# HISTORIC AND DESIGN REVIEW COMMISSION

**HDRC CASE NO:** 2023-257  
**ADDRESS:** 114 DEWBERRY ST  
**LEGAL DESCRIPTION:** NCB 6461 (MISTLETOE ADDITION SUBDIVISION), BLOCK 1 LOT 57  
**ZONING:** R-4, H  
**CITY COUNCIL DIST.:** 1  
**DISTRICT:** River Road Historic District  
**APPLICANT:** Jim Tafoya/Brio Builders  
**OWNER:** Daniel Pina/PINA DANIEL & STEPHANIE  
**TYPE OF WORK:** New construction of a two-story residence  
**APPLICATION RECEIVED:** July 20, 2023  
**60-DAY REVIEW:** September 18, 2023 (Requested postponement by applicant to September 20, 2023)  
**CASE MANAGER:** Jessica Anderson  
**REQUEST:**

The applicant requests a Certificate of Appropriateness for approval to construct a two-story residential structure on the vacant lot at 114 Dewberry.

FRONT - WEST ELEVATION

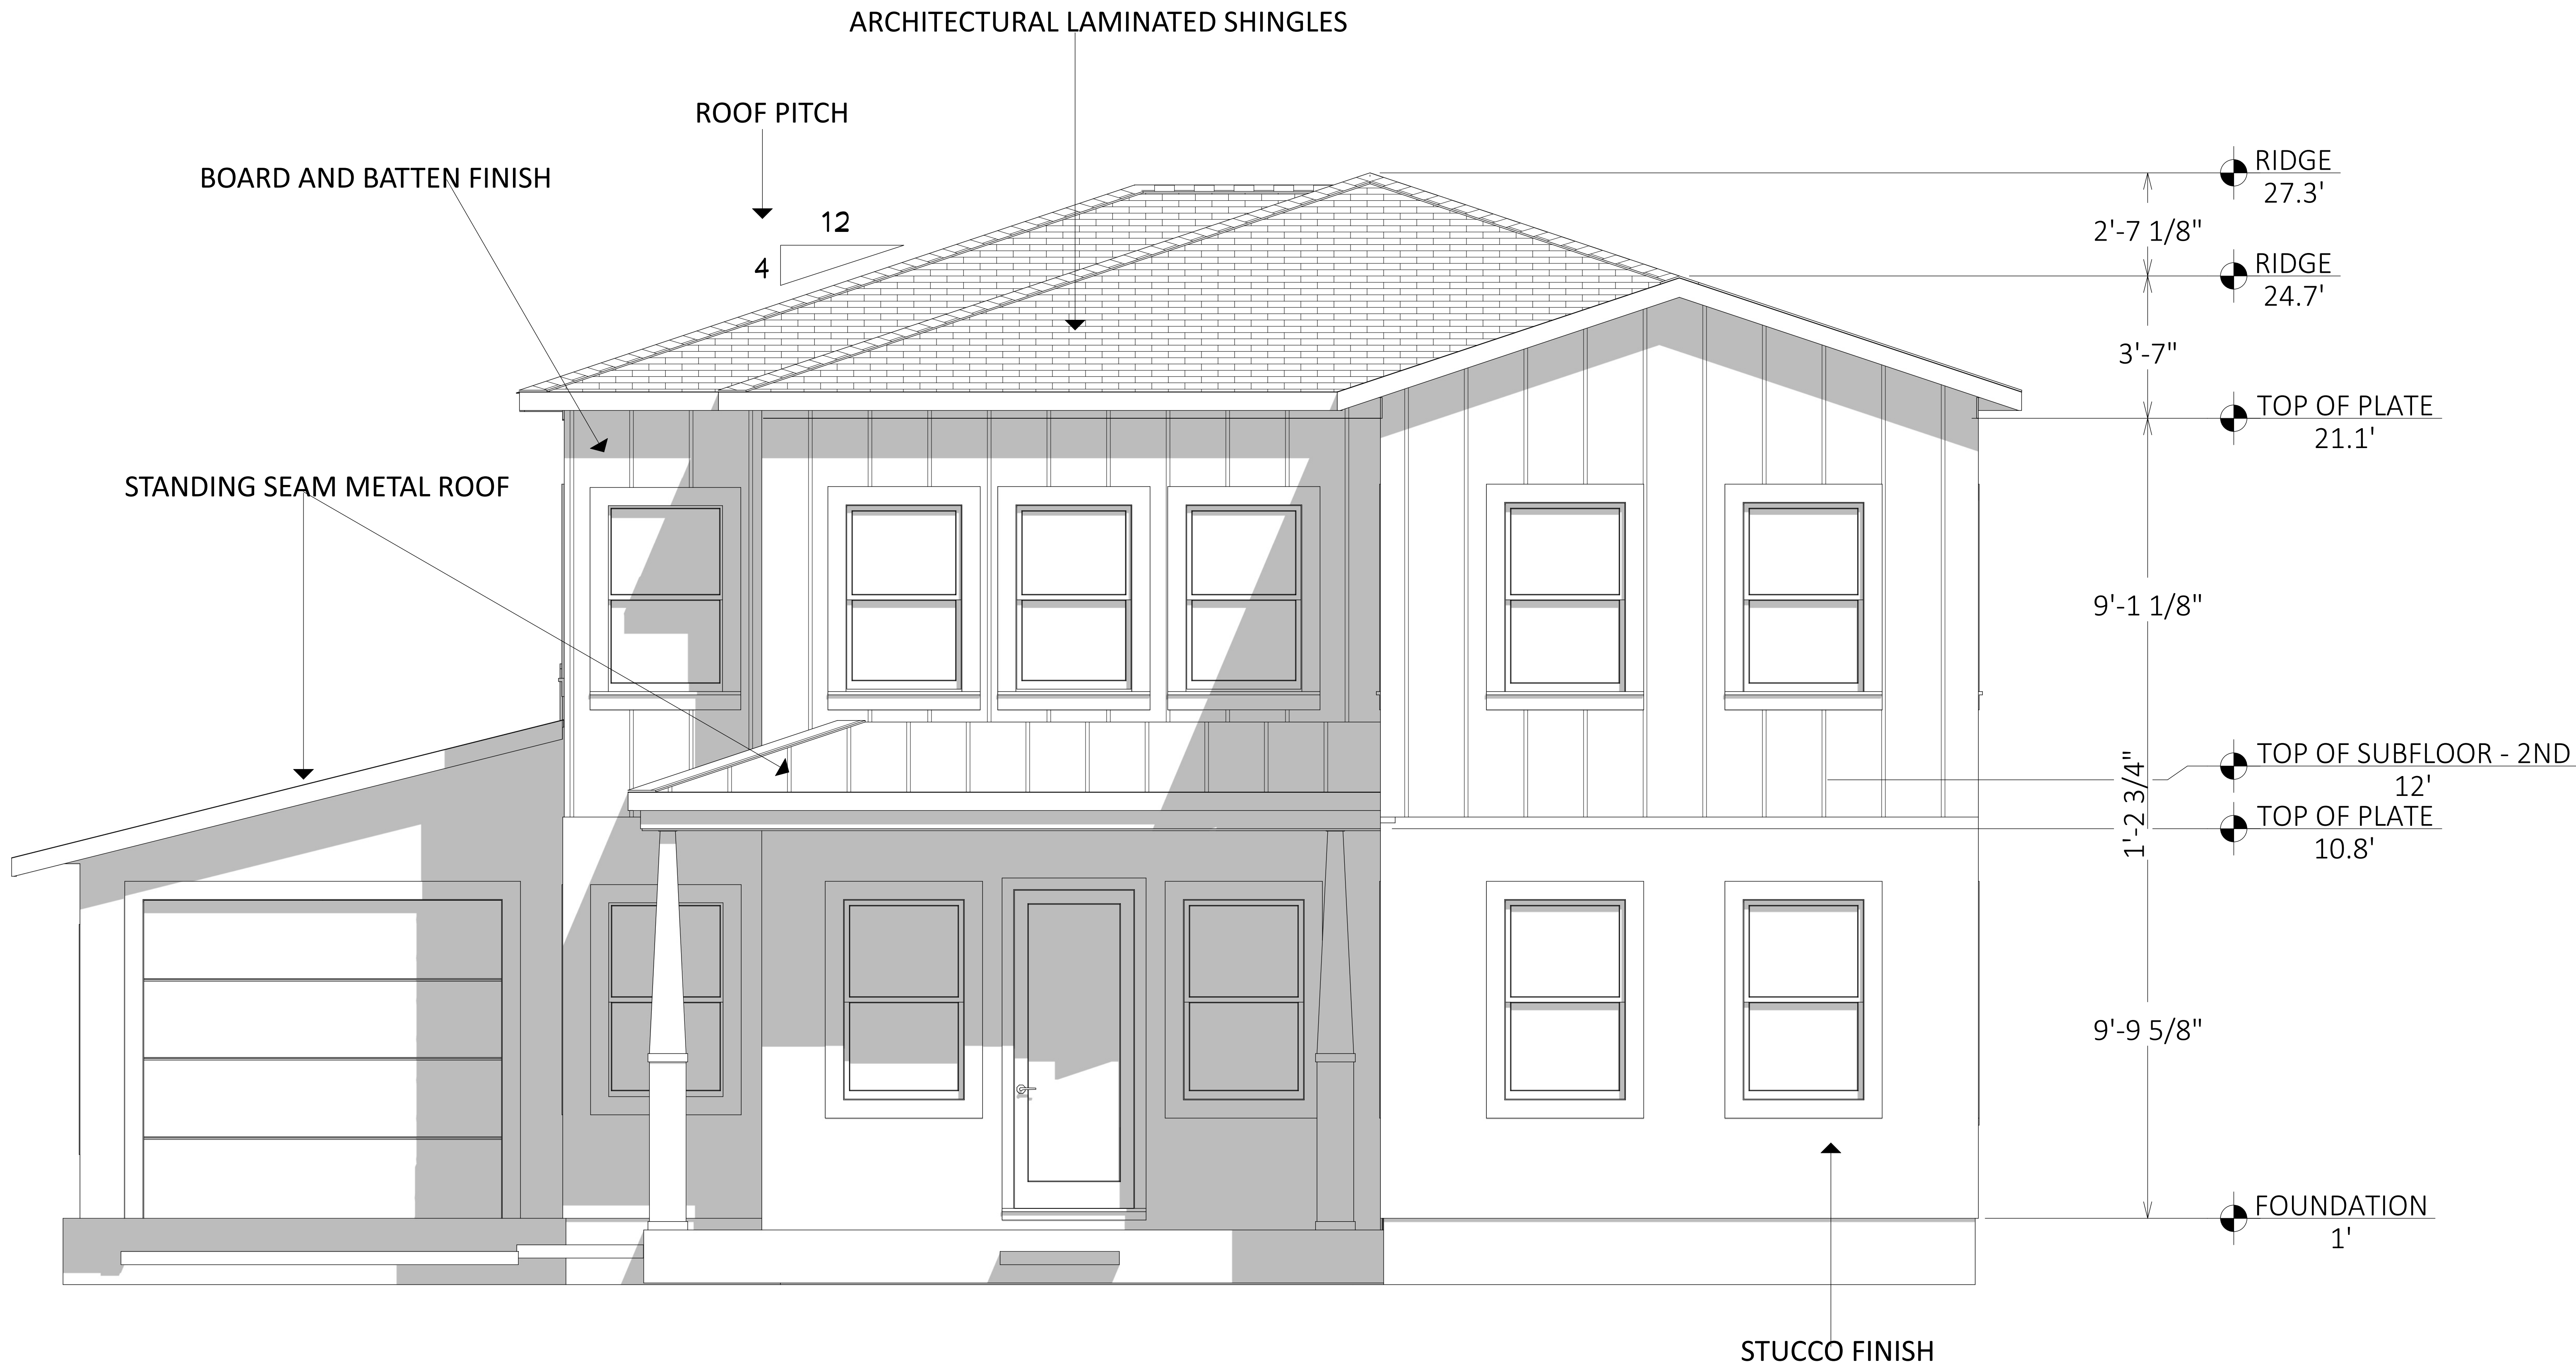
Fetzer: I would agree with Commissioner Mazuca. I think this is a much better, more traditional entry into the home with the location of the door rather than tucked around the corner, but the front elevation is composed around the front door and I think that's a much better design. I'm a little concerned about the size of the rear balcony. Based on your plan and your elevations, it's about 11'6" deep, which is almost doubling the size of your living room. And I'm not sure how that falls within the 20' setback line that development services would consider. I'm not sure the balcony would be considered complying with the 20' setback.

Fetzer: There are parts of the drawing on the left that get closer to addressing staff's concerns about the front porch. I think the one on the right, the hipped roof on the main body of the house, that is more successful than the big gable

Fetzer: If the hipped roof over the entrance became a gable roof, similar to the drawing on the right. And behind that, instead of the gable, do a hipped roof like on the last submitted design. With the gable, it's a much stronger entry element, especially with the center door, that starts to address some of the more traditional massing of the more historic houses. I would keep the one-over-one windows on the far right on the first floor.

Fetzer: We're just two of the commissioners, and there are more, and you need to talk to your client about moving the front door. If they're set on the floor plan, then you just need to make your case. It's only a suggestion, but if it doesn't work for your client, I can understand that. Don't feel that it's a mandate that you move the door. It's a suggestion to address the entry massing of the building.

10' PRIVATE SAN SWR ESMT.

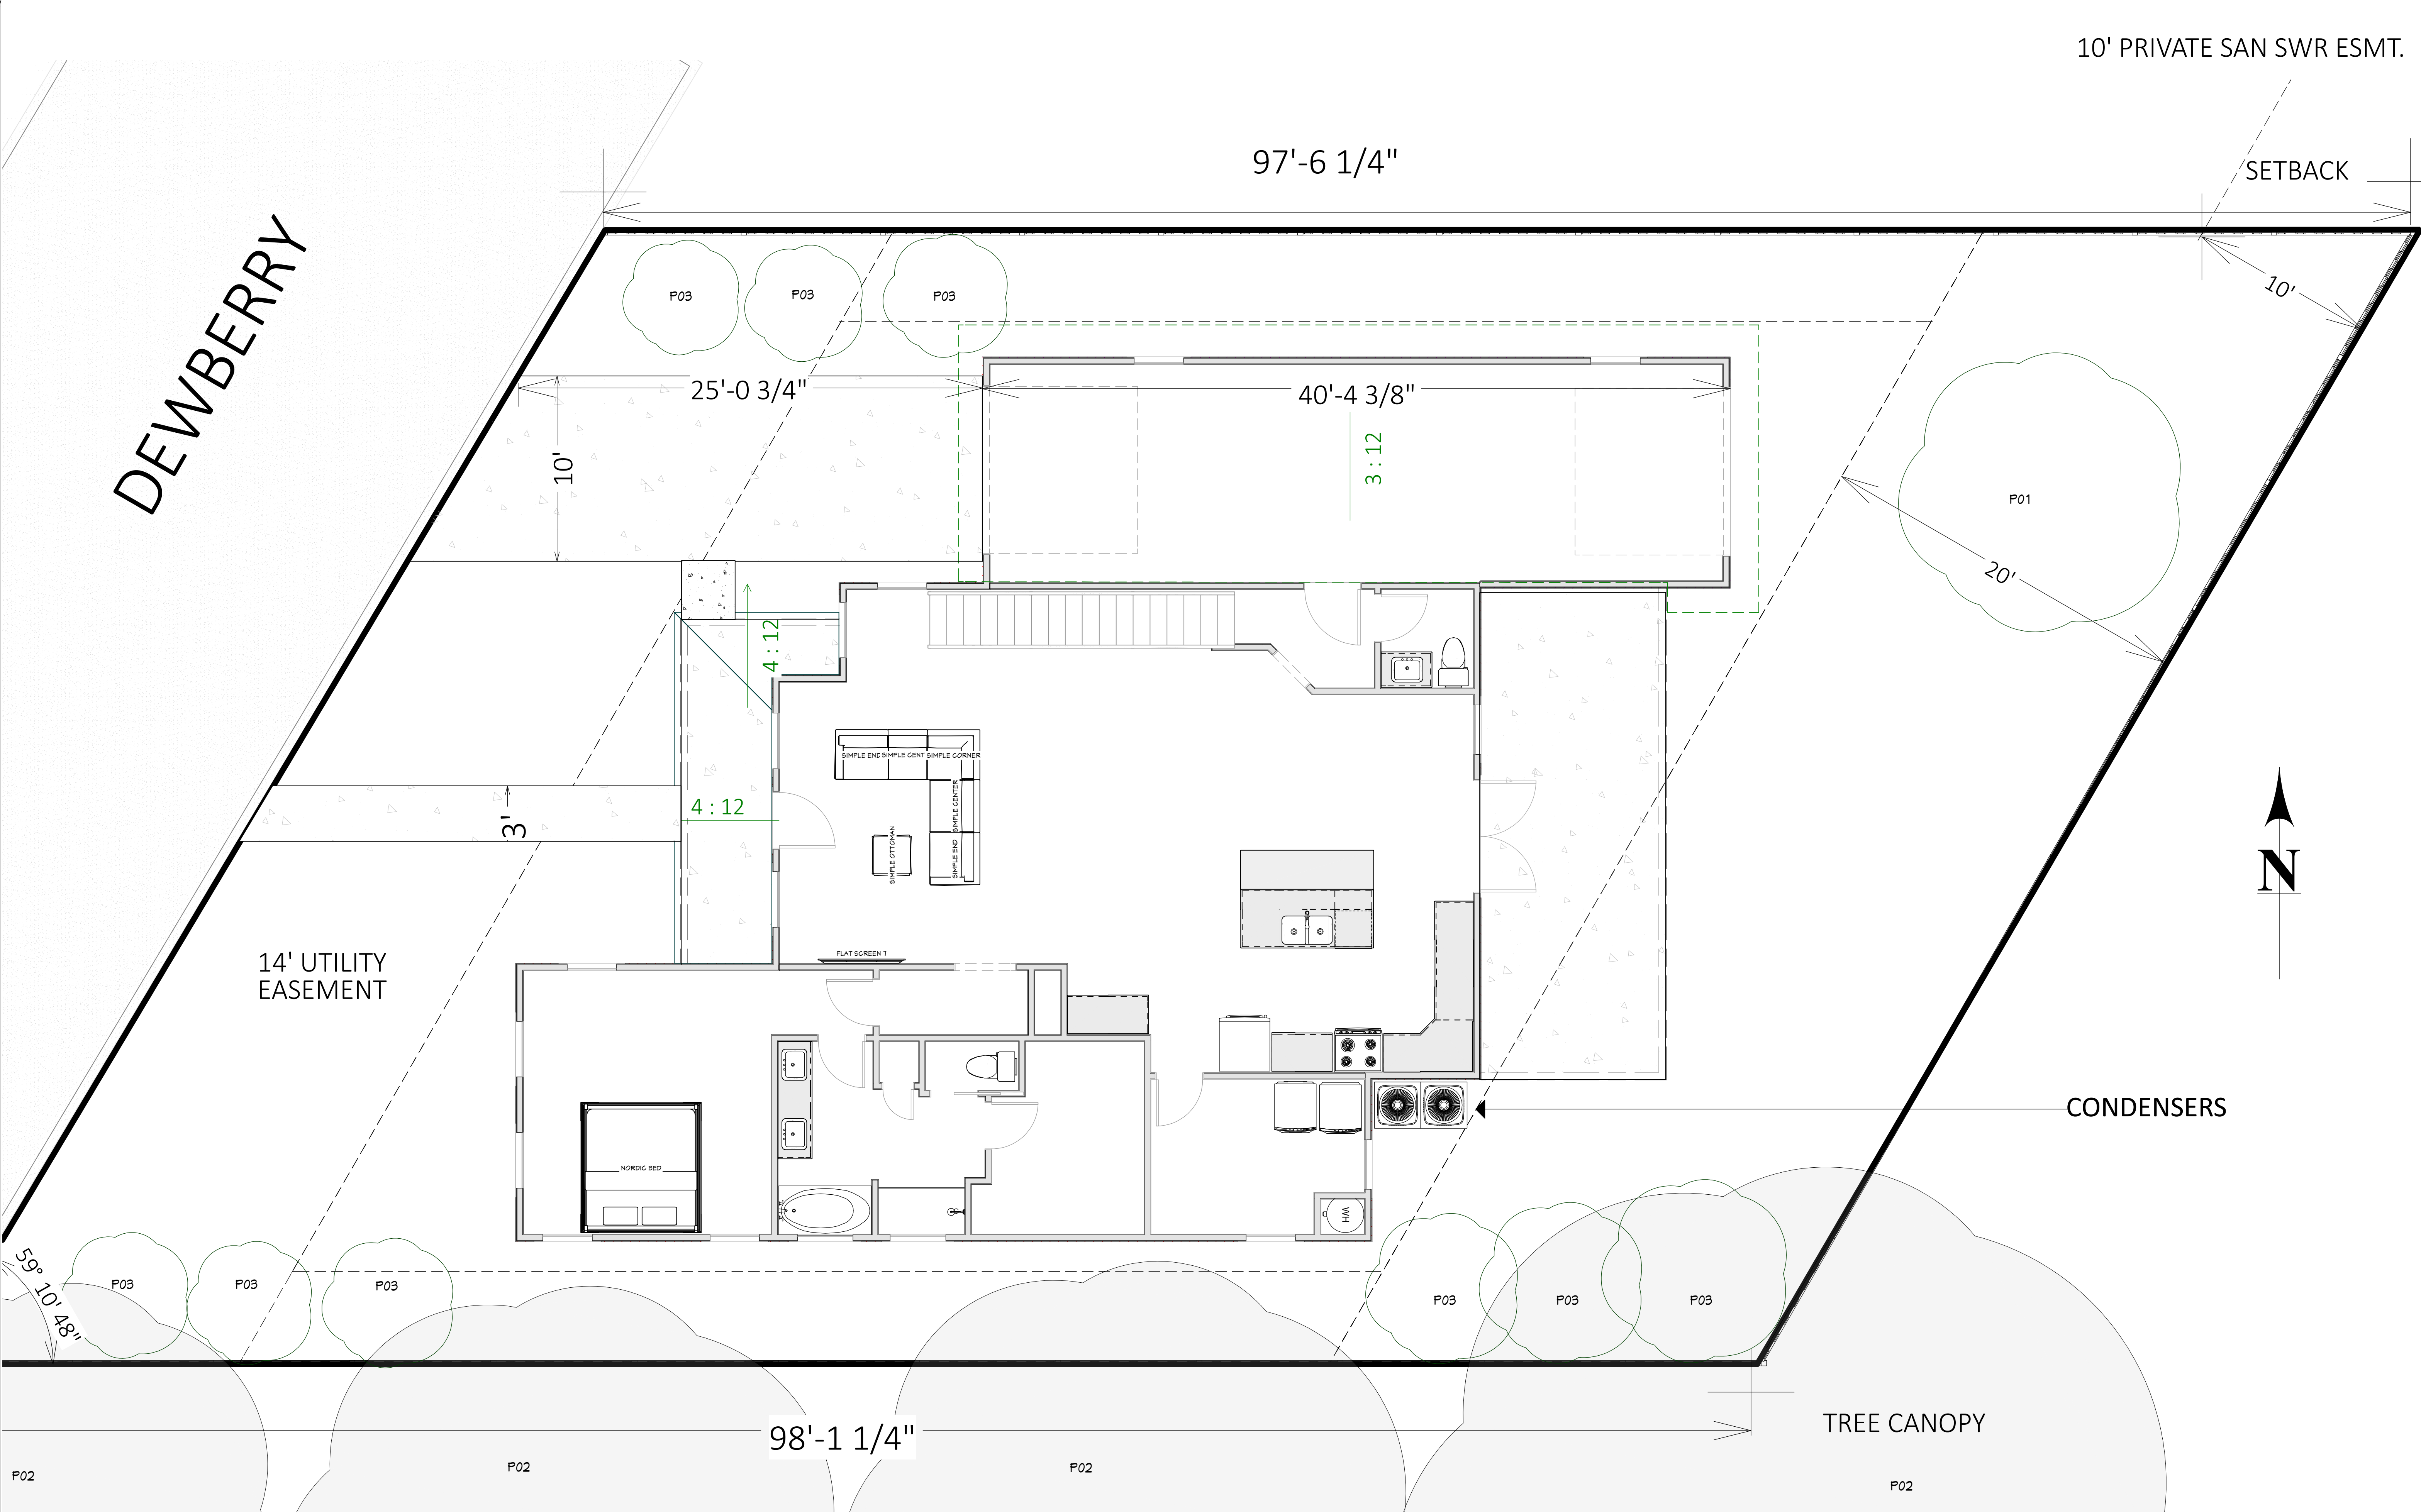
Fetzer: Based on the porch and 20' setback, both encroach. Need to confirm with DSD whether a balcony under the roofline of the main house can extend into that setback. The setback is probably not just on the ground plane, it's probably vertically too.

Fetzer: Get with DSD about what's allowable behind that 20' setback, whether you'd need to ask for a variance. Something that would be helpful on this plan is a distance from the southeast corner of the porch perpendicular to the rear property line. Is that also 10', or is it something else?

Fetzer: Would it be possible to add a diagonal line at that 20' setback on the site plan?

Fetzer: Update site plan to show changes (sheet 1-13)
